Sinclair College
Building 14 – EMS Classrooms & Sim Lab
FAC 24-28X
Dayton, OH

ADDENDUM 01

Date of Addendum: January 31, 2025

This addendum consists of five (5) pages plus attachments.

1 PARTIAL LOWER LEVEL FURNITURE & EQUIPMENT PLAN
 1/8" = 1'-0"

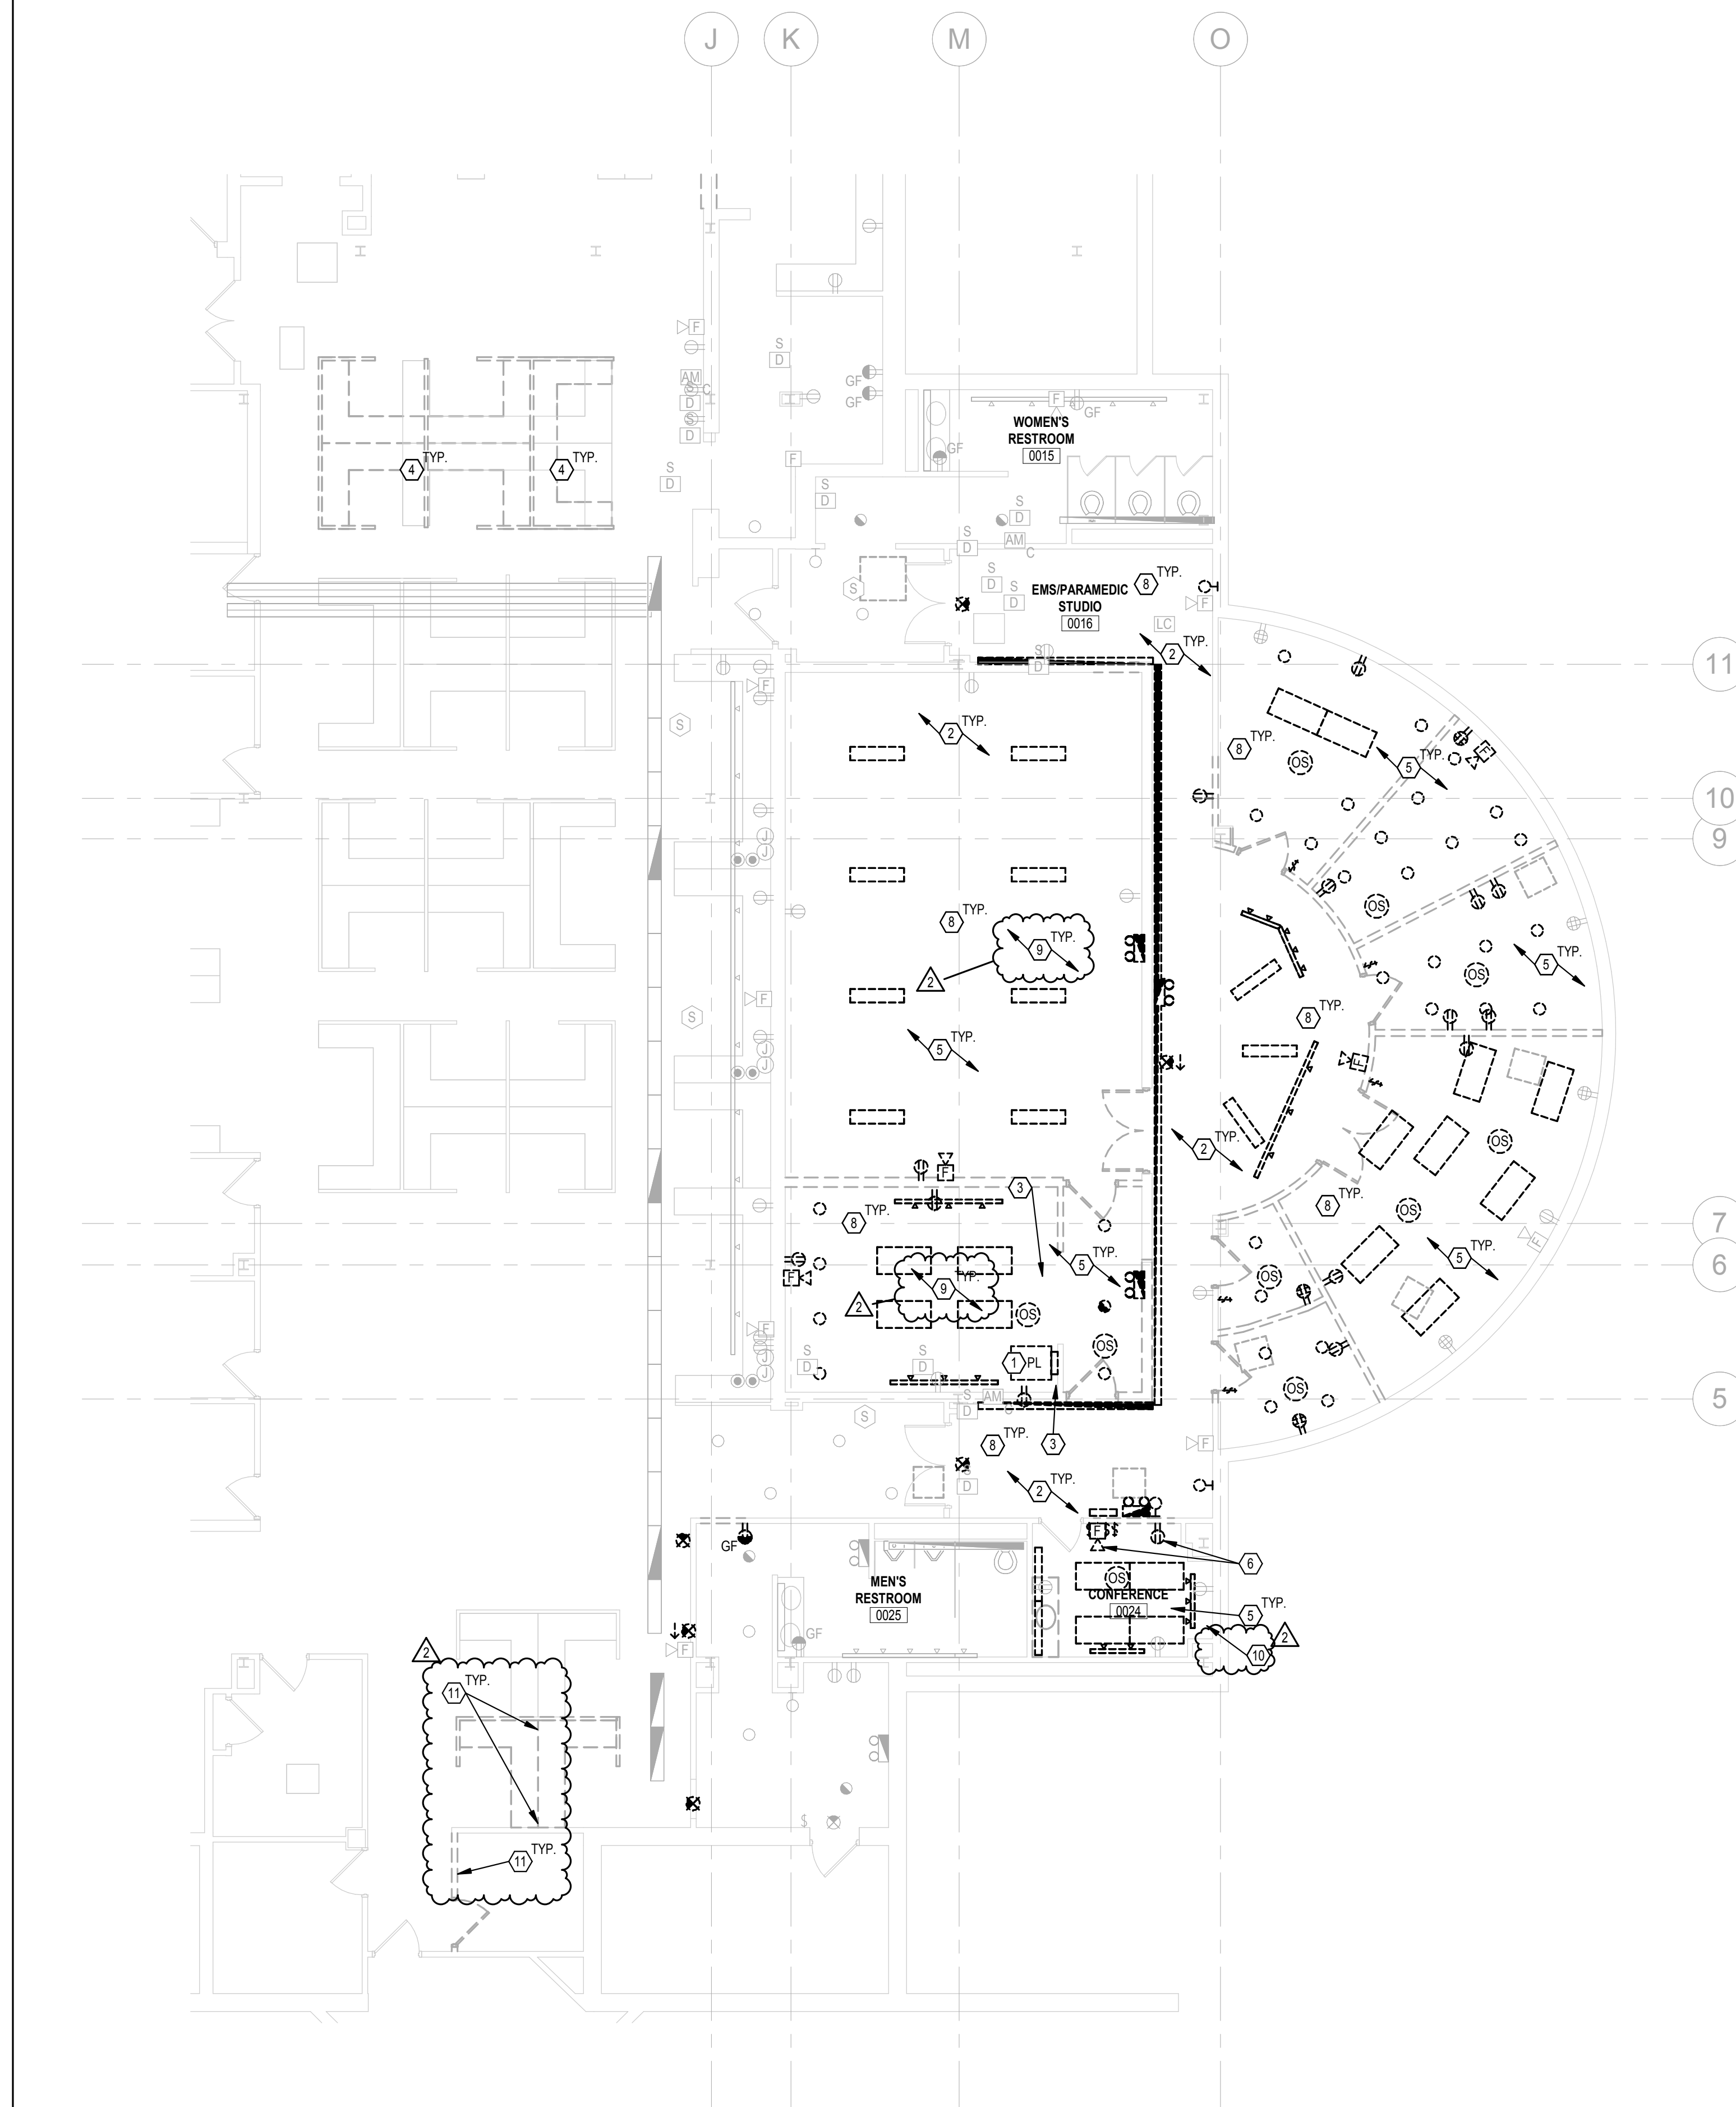
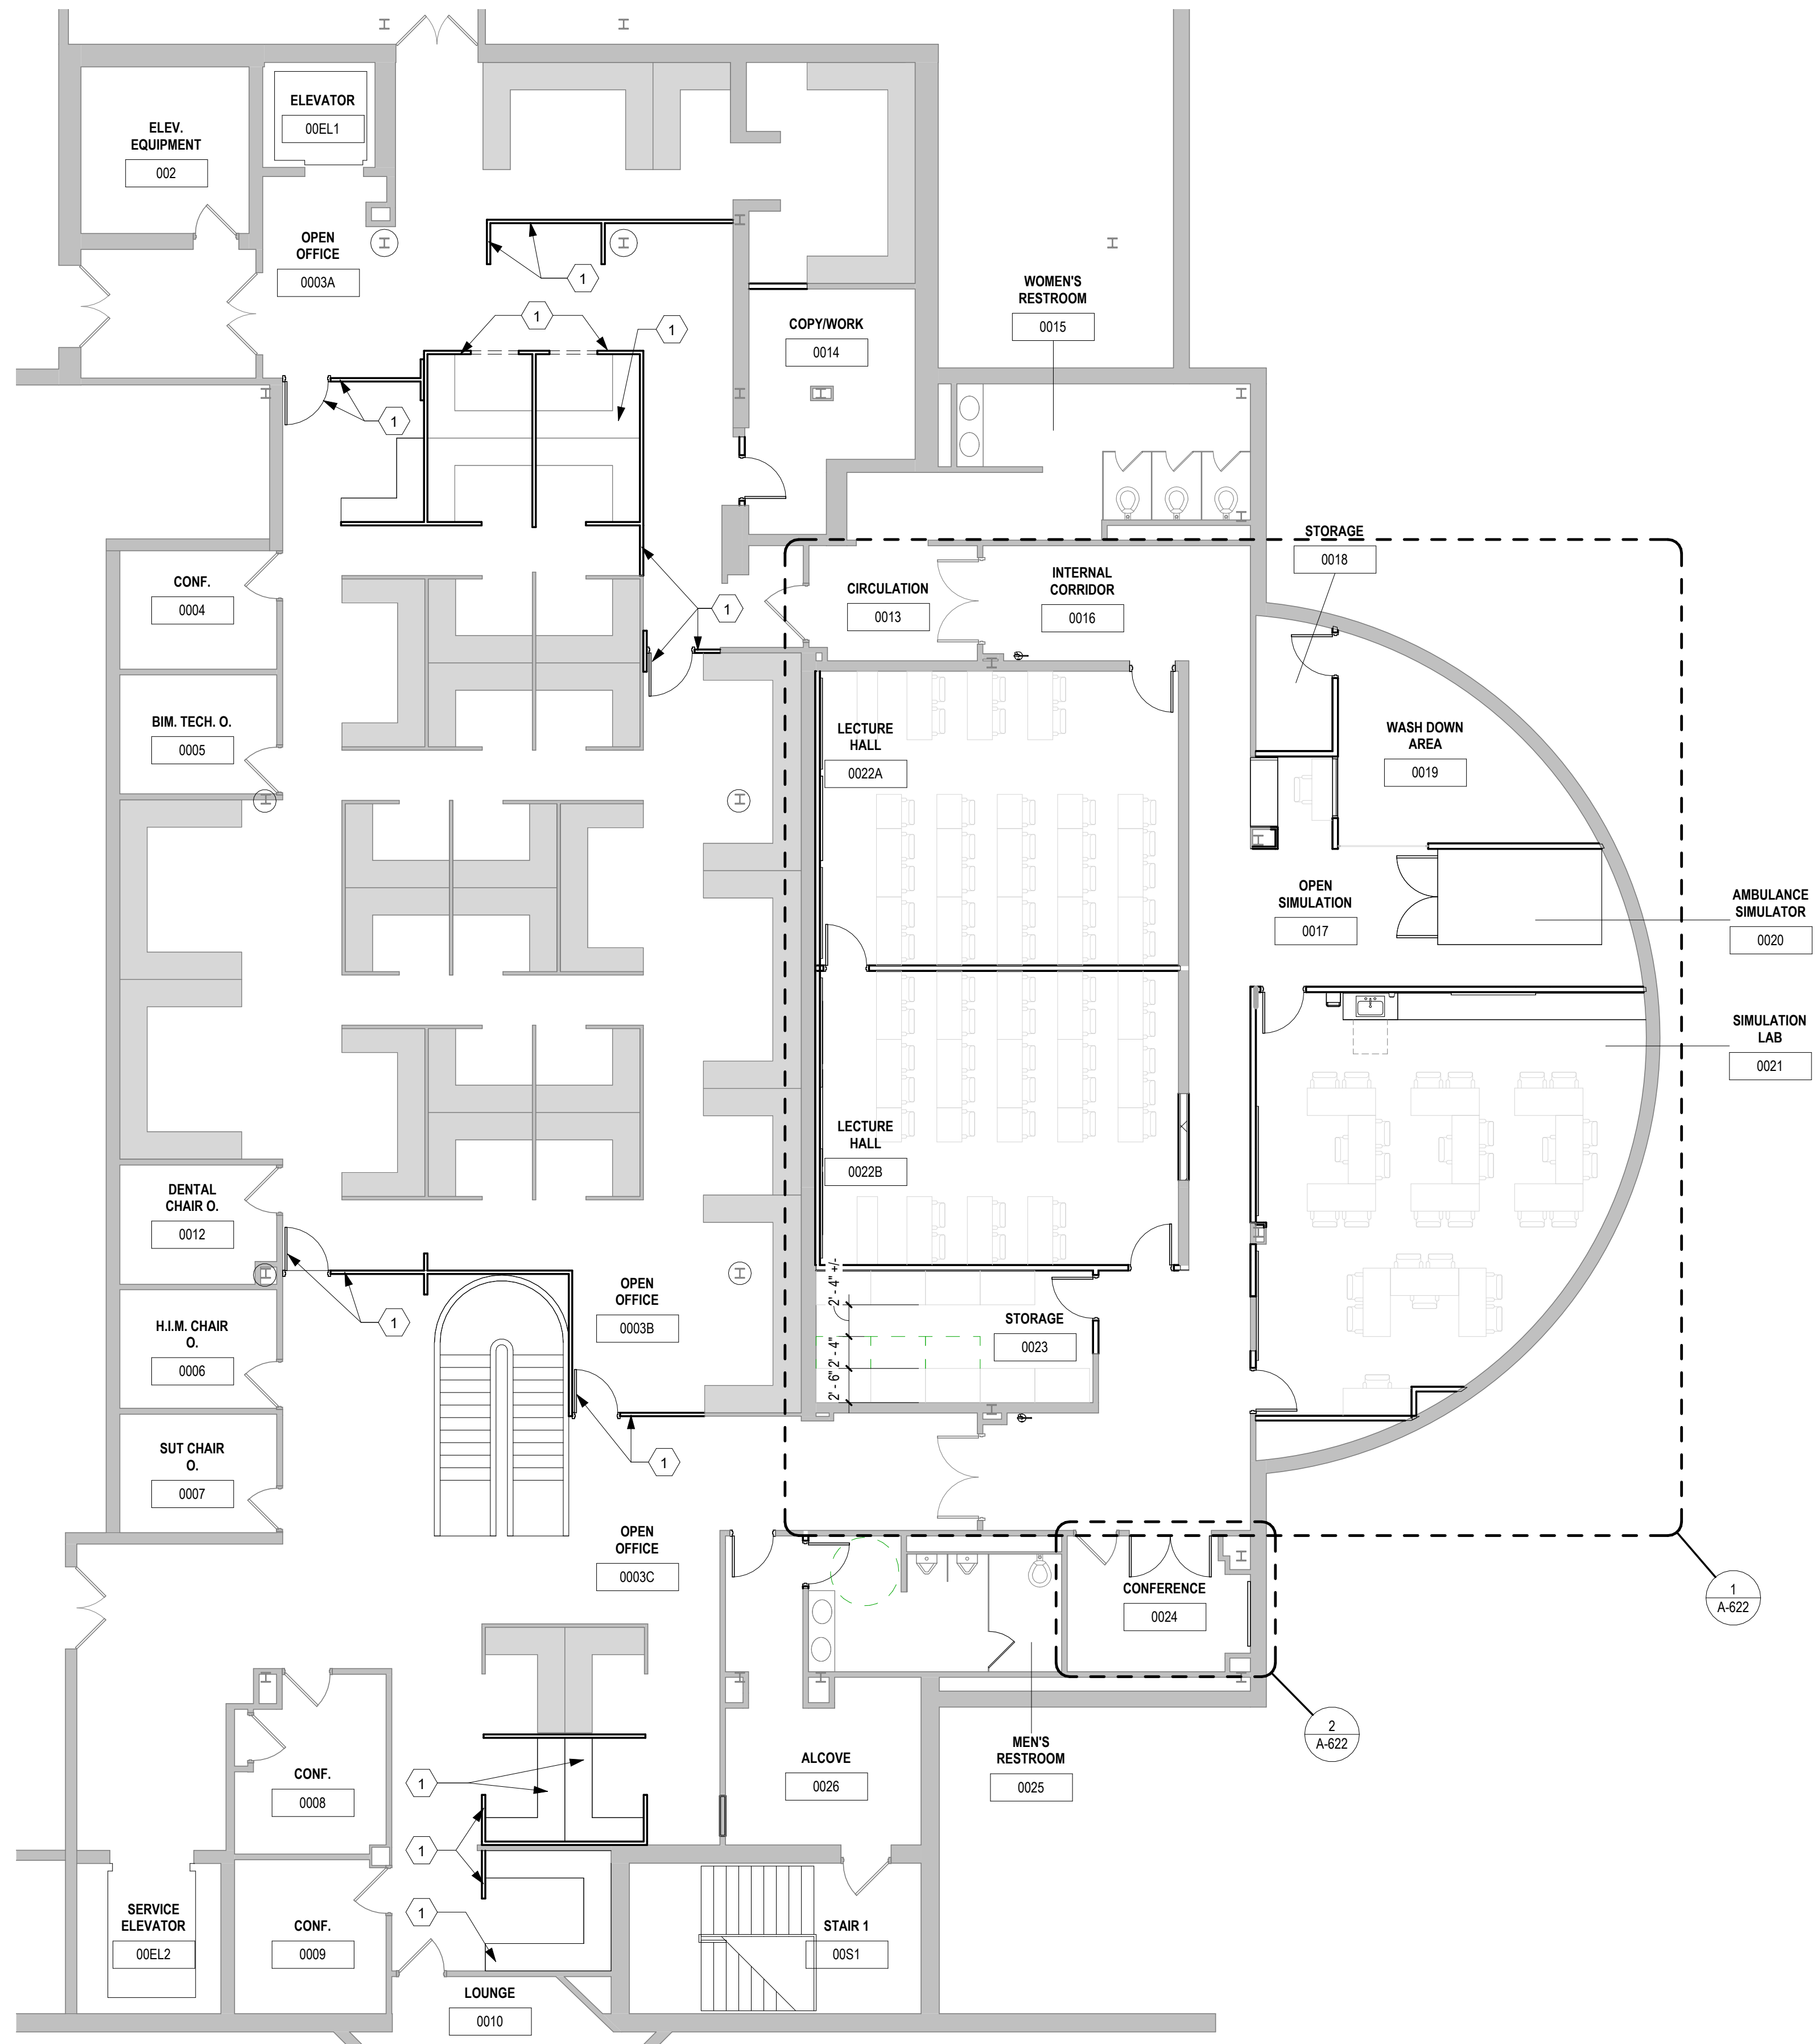
5. Sheet A-621 PARTIAL LOWER LEVEL FURNITURE & EQUIPMENT PLAN:
 - a. Add "ALLOWANCE NO. 1" designation to CODED NOTE 1.
6. Sheet E002 PANEL SCHEDULES & SINGLE LINE

LOWER LEVEL FLOOR PLAN - DEMOLITION

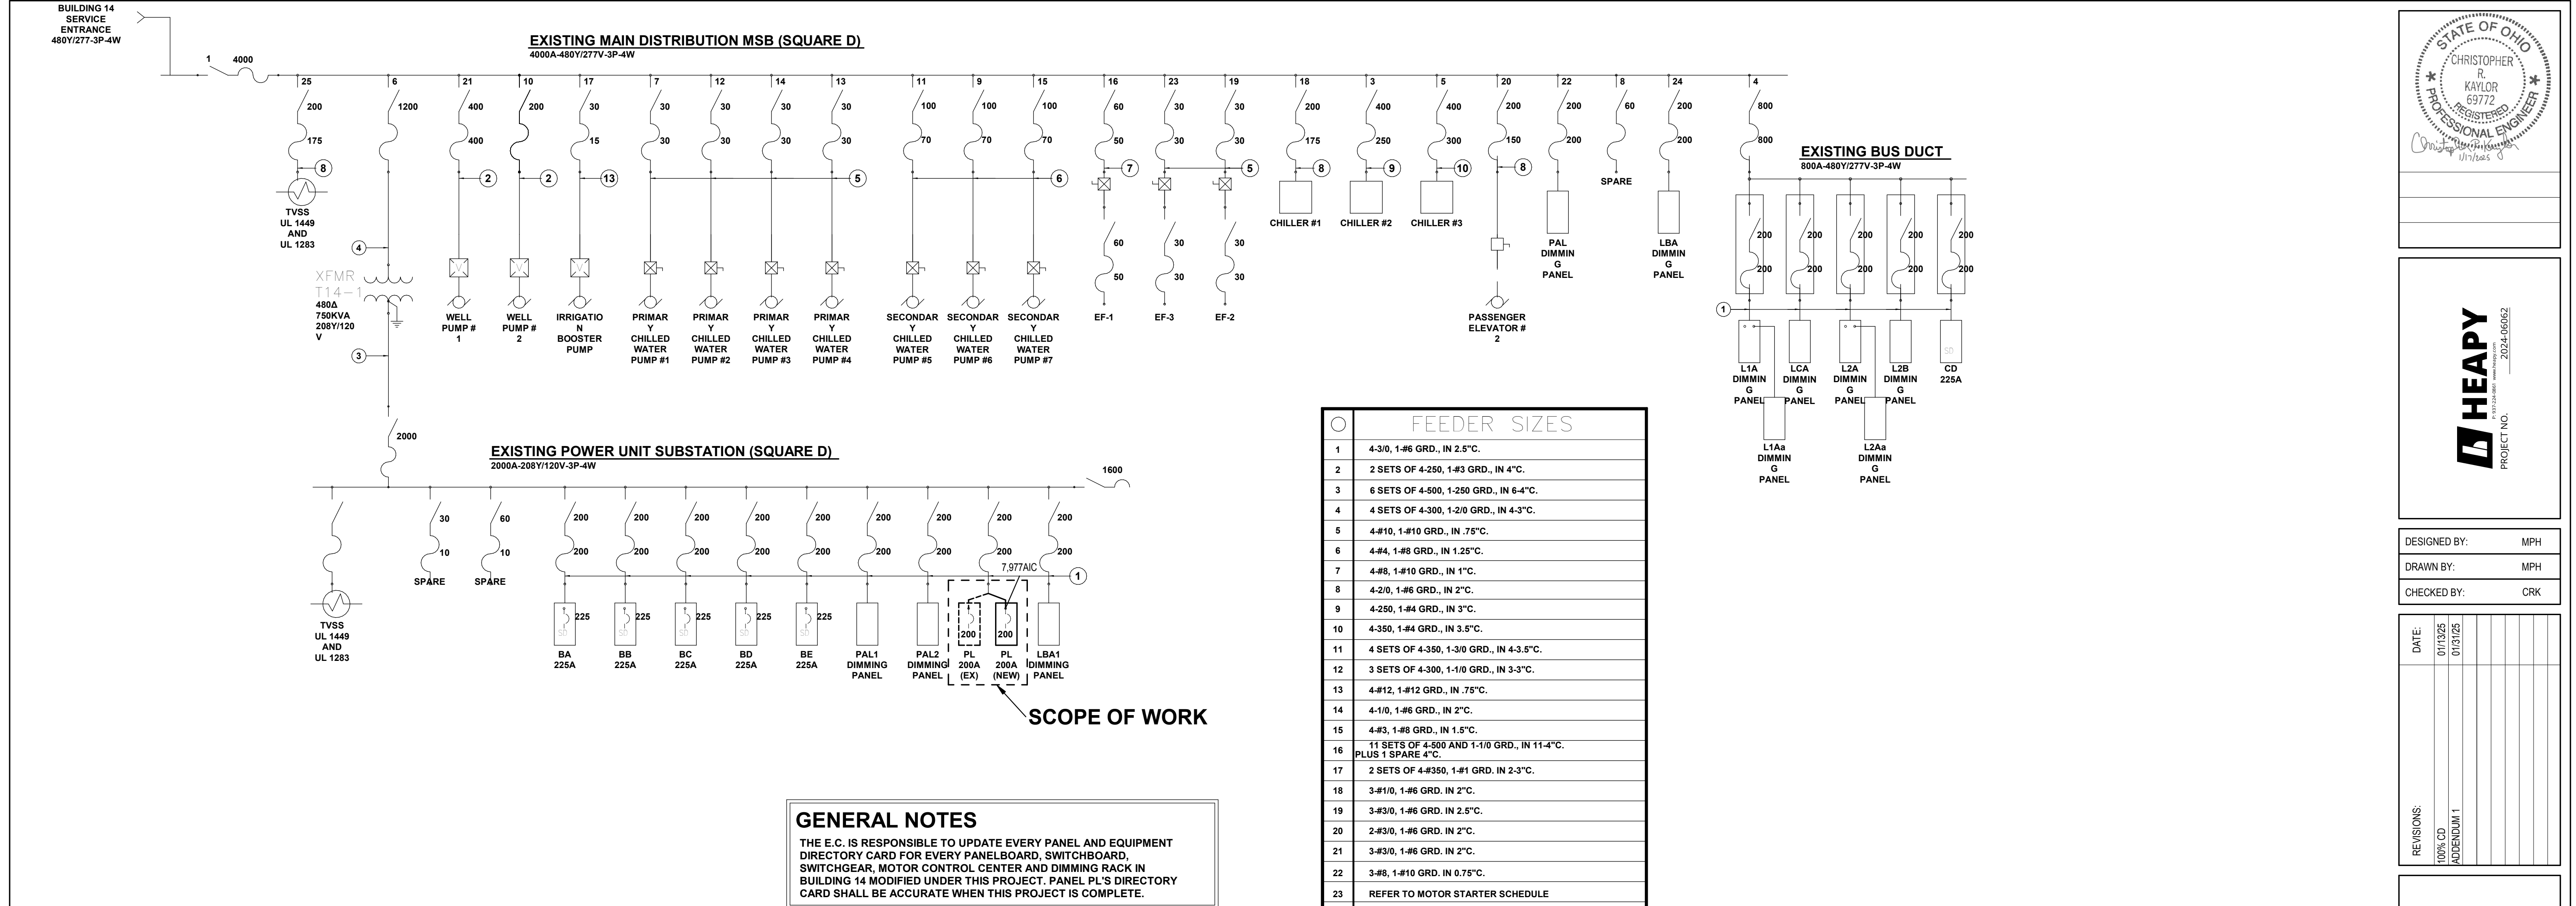
- b. Add (6) receptacles to 0023 with (2) circuits.
 - c. Add Plan Note 16 along with instance on plan for revised furniture under Alternate 2.
10. Sheet ED100 LOWER LEVEL FLOOR PLAN - DEMOLITION

- a. Add Plan Notes 9, 10 & 11, along with instances on plan.
11. Sheet T001 TECHNOLOGY LEGEND
